Committee Date	14/10/21	
Address	26 Manor Road Beckenham BR3 5LE	
Application Number	21/00548/FULL1	Officer - Susanna Stevenson
Ward	Kelsey And Eden Park	
Proposal	Elevational alterations and second/third floor upward extension to existing building incorporating mansard roof and front and rear dormers, excavation of basement and lightwells and construction of four storey rear extension. Conversion of resultant building into 5 no. residential flats (3 no. two bedroom and 2 no. 1 bedroom) with balconies/terraces at first, second and third floor. Formation of surface car parking spaces at rear, provision of rear cycle and refuse storage and 2 no. electric car charging points at front.	
Applicant	Agent	
Richard Percy 20 Barnfield Wood Rd Beckenham BR3 6SR	Mr Keith Chandler 37 Glenthorne Ave Croydon CR0 7ET	
Reason for referral to committee	Call-In	Councillor call in Yes

RECOMMENDATION	REFUSE PLANNING PERMISSION
-----------------------	-----------------------------------

UPDATE

Revised front elevation (2/8/21)

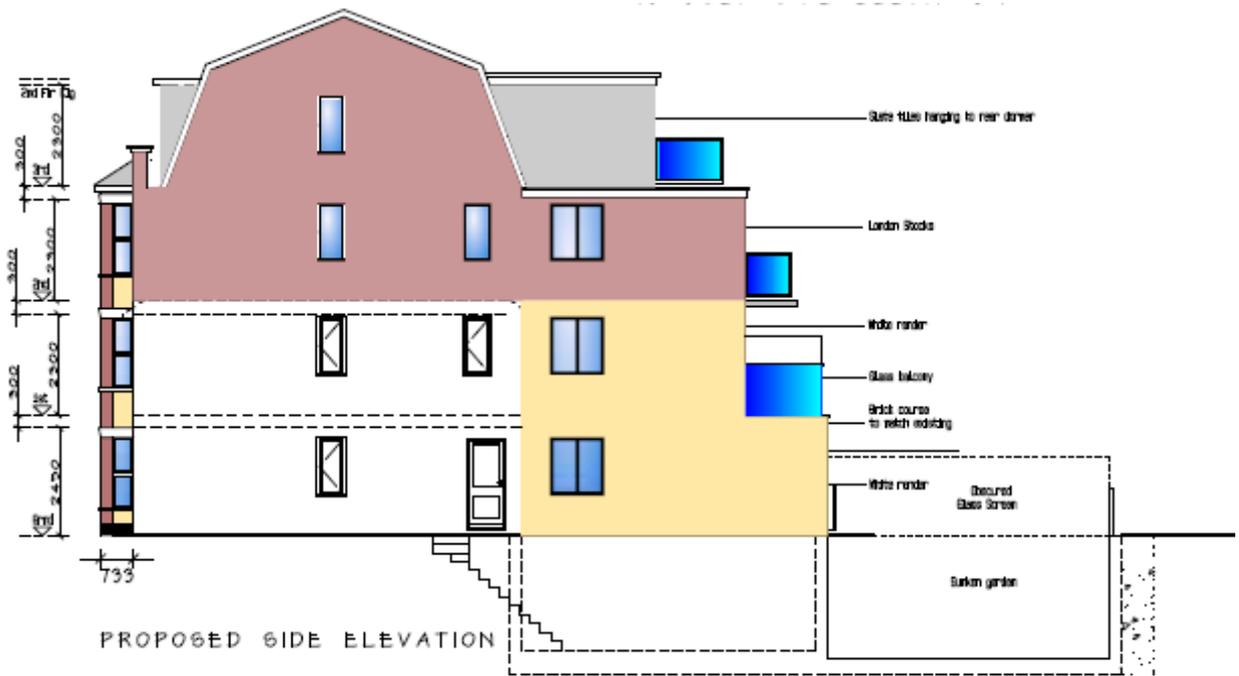
- 3.0 The amendments to the proposals as provided within the revised drawings received 2/8/21 can be summarised:
- Reduction in width of the proposed building by 0.45m – attendant increase in width of accessway to rear.

- Formation of three storey symmetrical bay windows to either side of the building, additional centrally positioned first and second floor windows to front elevation,

- 3.2 The resultant building would be converted to provide 5 no. residential flats (4 two bedroom and 1 one bedroom).
- 3.3 The proposals would increase the height of the front of the building, with the parapet height proposed being approx. 8.7m. The existing eaves height of the building is approx. 5m. The ridge height of the roof would be approx. 11.8m where the existing ridge height is approx. 8.2m. The front mansard roof slope would incorporate 2 no. dormers.

Revised proposed side elevation (2/8/21)

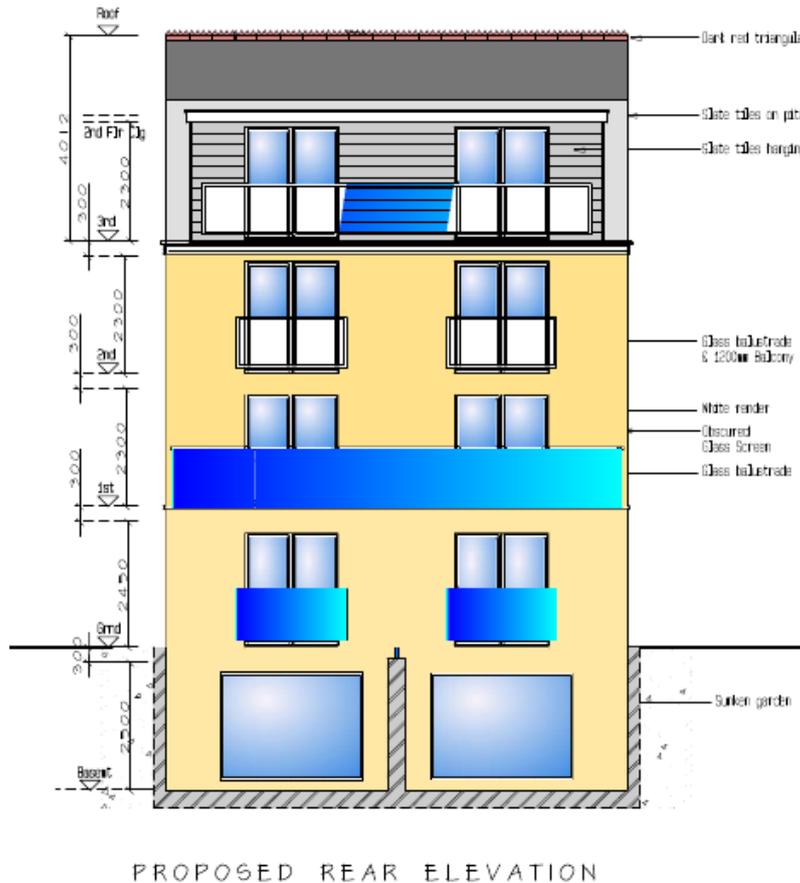
- 3.8 The revised drawing shows a separation of 3.074m to the boundary with No. 24 (on the other side of the access alley).
- 3.9 At the rear of the site it is proposed to provide three car parking spaces, refuse storage area and covered and lockable cycle storage.

Revised front elevation (2/8/21)

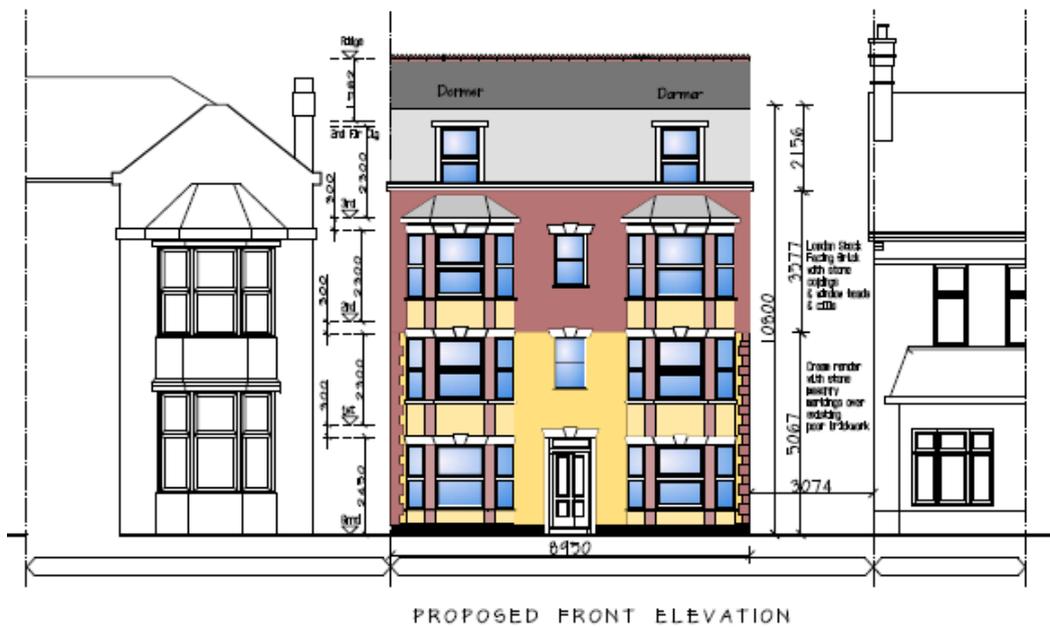
7.3.13 The proposed development would significantly enlarge the host building. In upwardly extending the property while maintaining its width when viewed from front

and rear the proposal would result in a somewhat disproportionate and visually unsatisfactory appearance, with the height of the building appearing excessive in the context of the width of the property, which has now been further reduced in order to provide increased width to the side access to the parking spaces at the rear.

7.3.14 The proportions and positions of the windows, including the front facing dormer windows, would result in a visibly four storey appearance from the front which would contrast unfavourably with the neighbouring Victorian buildings which share a recognisable two storey appearance incorporating design detailing that contributes positively to the visual amenities of the street scene. The height and massing of the development would obscure the existing visibility of the articulation of the flank elevation of the neighbouring building at No. 28.

7.3.15 While there are limited examples of front dormers within the street scene, these are not characteristic of the development at roof level in the locality, and are generally set well within the reasonably uniform pitch of the front roof slopes. In contrast, the proposed dormers in tandem with the mansard and parapet would result in a top heavy and overbearing appearance to the development.

Current proposed side elevation

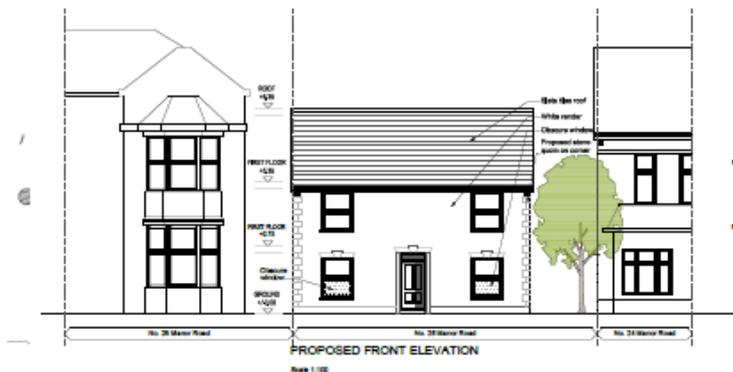
7.3.16 Under reference 15/03084 planning permission was refused and dismissed on appeal for a less visually dominant development (when viewed from the front):

Dismissed at appeal under reference 15/03084

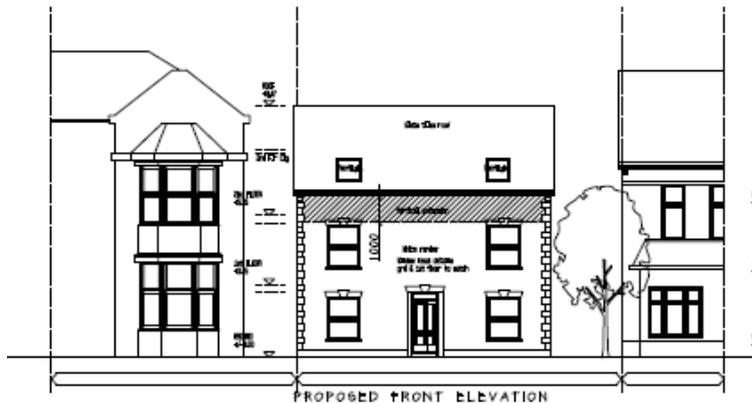
7.3.17 In dismissing the appeal, the Inspector noted with regards to the front elevation that:

“With the proposal the front elevation of the building would be white painted rendered which would increase the prominence of the building within the street scene. The proposed replacement windows and large expanse of render above the central door would result in the front elevation being plain, with strong and uncharacteristic horizontal lines. In addition, due to their size, proportions and

detailing the proposed windows would fail to respect the proportions, size and detailing of the proposed central door.”

Granted planning permission under 18/00998

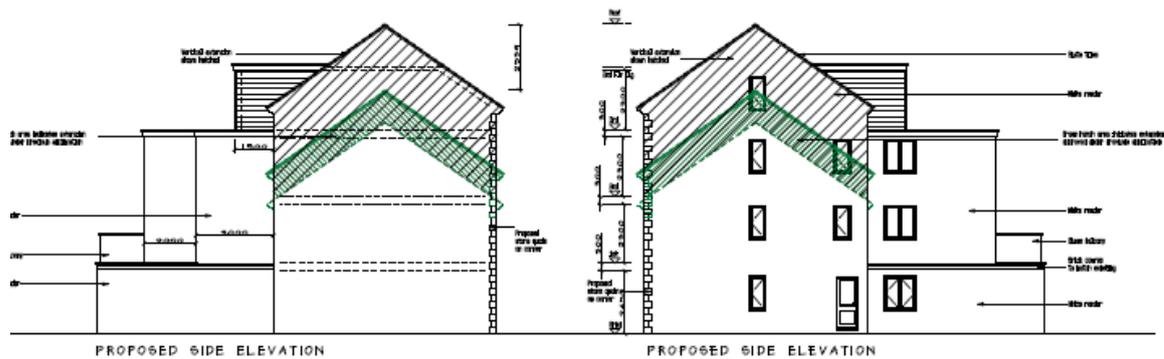
7.3.19 It is considered that the proposed development would appear bulky and obtrusive from the street scene and that the current proposal does not in terms of the external design of the development address the grounds for refusal of the most recent application under reference 19/03229/FULL1. While the proposal replaces the previously proposed dual pitched roof with parallel ridgeline with a mansard roof with front dormers, this does not reduce the overall bulk of the proposed development and in fact introduces two front facing third floor dormer windows in place of the rooflights previously proposed. As such the accommodation at third floor/fourth storey level is more readily appreciable from the front than the previous proposal. This results in development uncharacteristic of the surroundings, including the immediately neighbouring properties to either side.

7.3.20 From the side and rear the proposed extensions would appear disproportionate in the context of the host building, leading to an unattractive and excessively high appearance to the side elevations with the scale of the development emphasised by the fenestration which would signal the four storey development which is uncharacteristic of the scale of development in the locality.

Flank elevations refused 19/03229/FULL1

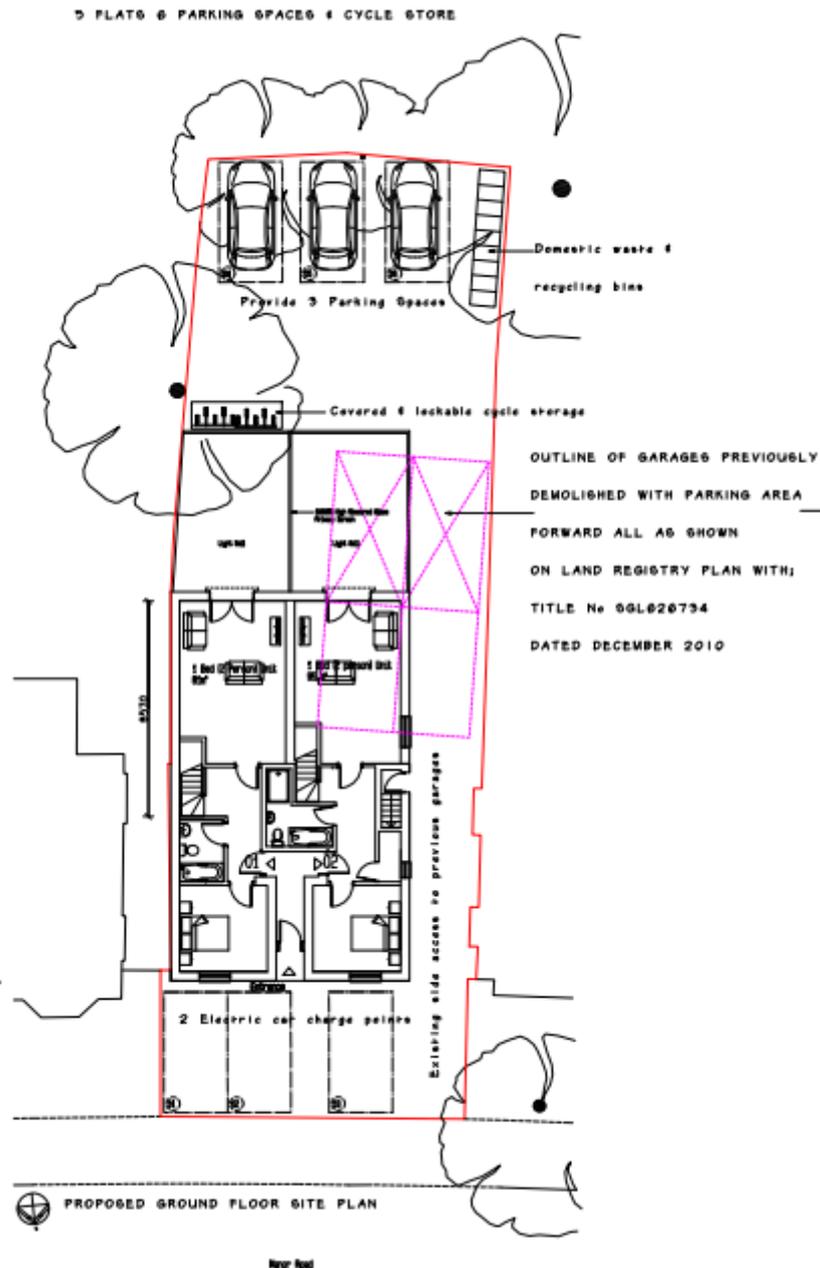
7.3.22 The ridge height of the current proposal exceeds that of the neighbouring dwellings at Nos. 24 and 28, in contrast to the previous proposal where the ridge height was set lower than that of the neighbouring properties. As scaled from the submitted drawings the ridge height would be approx. 0.5m higher than the neighbouring dwelling at No. 28, where the ridgeline is offset from the boundary as the property at No. 28 has a hipped roof to the side. The proposed ridgeline would be approx. 0.8m higher than the ridgeline to No. 24 which has a gable ended roof profile immediately adjacent to the boundary.

7.3.23 The height of the resultant building would exceed appreciably at ridge height the neighbouring dwellings at Nos. 24 and 28 and would incorporate a bulky and visually obtrusive, uncharacteristic mansard element with front facing dormers. Taking into account the boxy design and the clearly evident four storey appearance of the building it is considered that the height and form of the resultant building would be out of character with the street scene and would represent a jarring feature detrimental to the visual amenities of the area.

7.3.24 The space to the side boundaries of the site in the context of the significant height of the building and the barn/gable ended roof design would result in a cramped appearance particularly in relation to the eastern boundary with No. 28. The overall height and design of the building in the context of the width of the site would result in a cramped appearance.

First, second and third floor plans currently proposed (3/8/21)

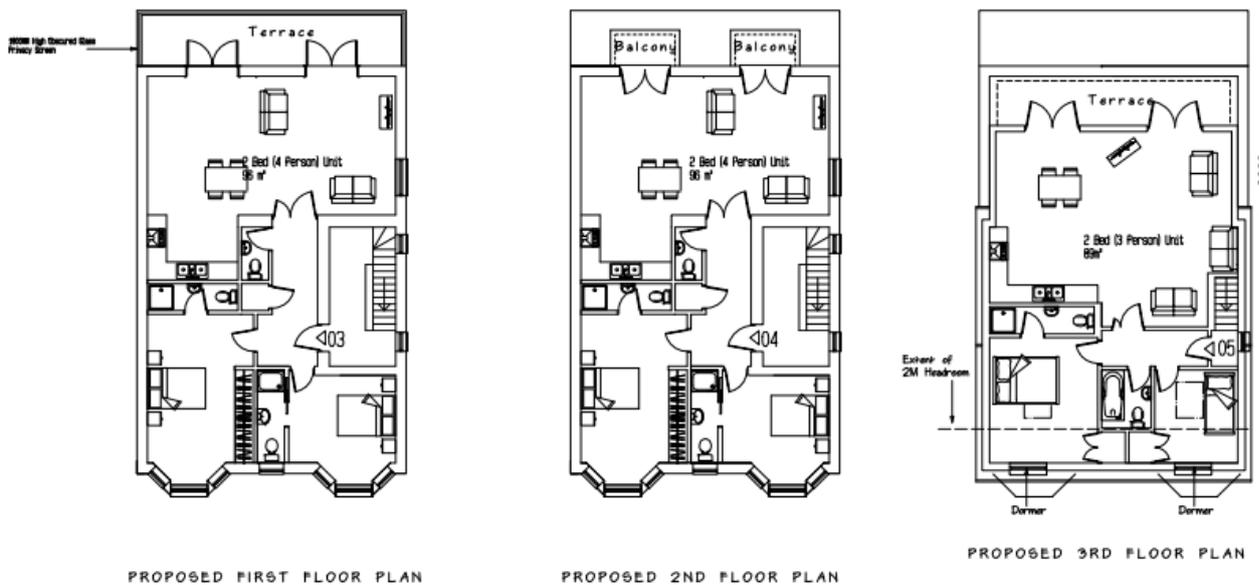
7.4.10 While it is acknowledged that the neighbouring buildings are set to the rear of the application building at present and in the case of No. 24, has been subject to extensions, the proposed rear extension would project to the rear at three storey height (with the rear dormer set partially above this projection) rather than the two storey height found to be acceptable under reference 18/00998 and without the stepped rear elevation refused planning permission under reference 19/03229.

7.4.11 As a result of the increased scale and height of the development it is considered that the extended (upwards and rearwards) flank elevations would be overdominant and visually intrusive when viewed from the neighbouring properties. Where the refused scheme under 19/03229 included within the floorplans indication of the relationship between the projection of the rear development relative to No. 28, the current floorplans do not show this relationship. However, the proposal would result in an increased depth of development relative to this neighbouring property, set over 4 floors above ground level as well as rear balconies. Taking into account the increased depth of the development it is considered that the proposal would appear overdominant visually when viewed from the rear garden at No. 28 as well as in relation to the recessed windows within the rear elevation of that property close to the boundary.
